## City of Ryde Submission

### BaptistCare Macquarie Park Masterplan- SSD-46561712

**Submission Date: 16 February 2023**

Figure 18: Markup of Proposed Staging Plan (Base Source: Appendix E Architectural Urban Design Report, Page 64)

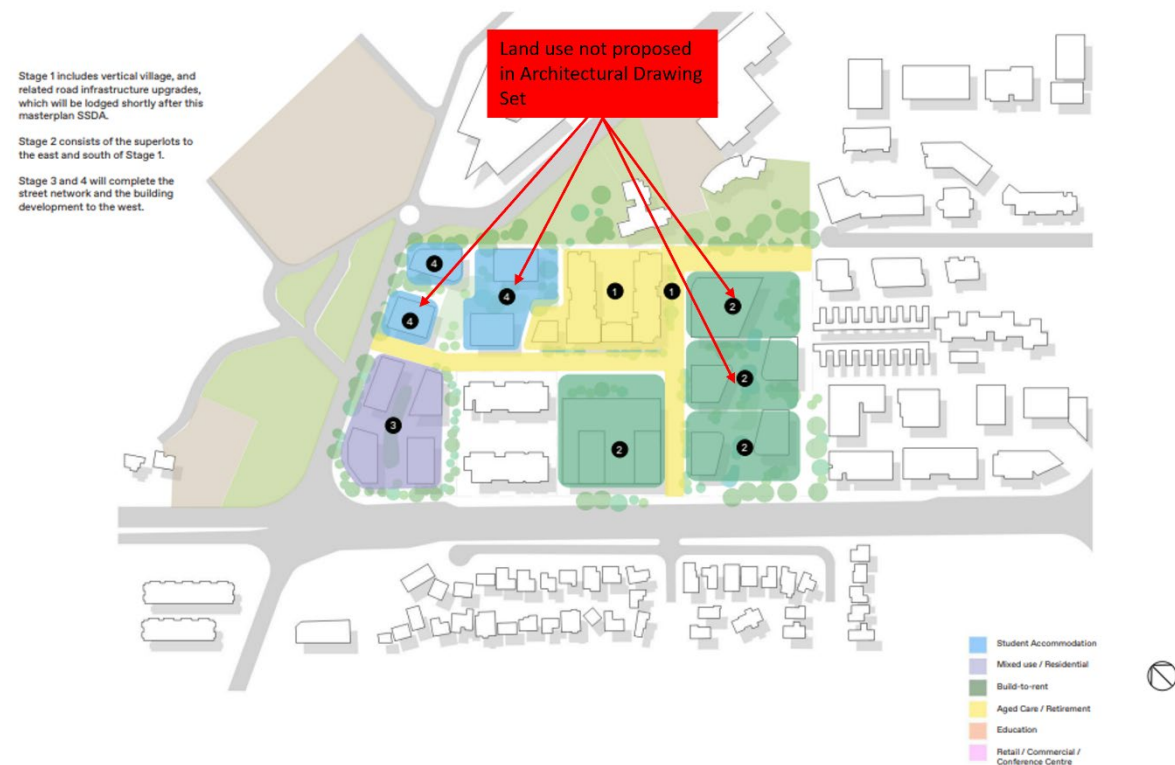
- The Architectural Drawing set shows the site split into different stages with associated land uses. In review of the Architectural Urban Design Report (Appendix E, refer page 64), it

shows different land uses proposed in stage 2 and stage 4 (Figure 20), when compared to

Figure 19: Proposed Land uses (Source: Architectural Drawing Set, Page 1)

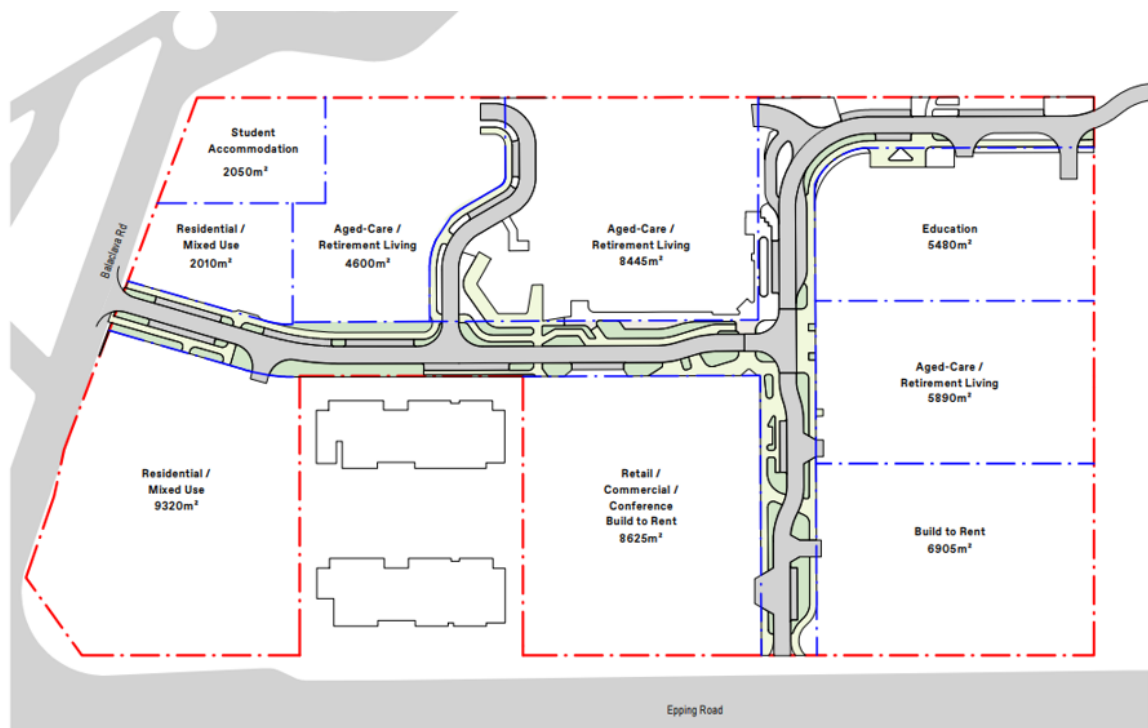
the submitted Architectural Drawing Set (Figure 21).
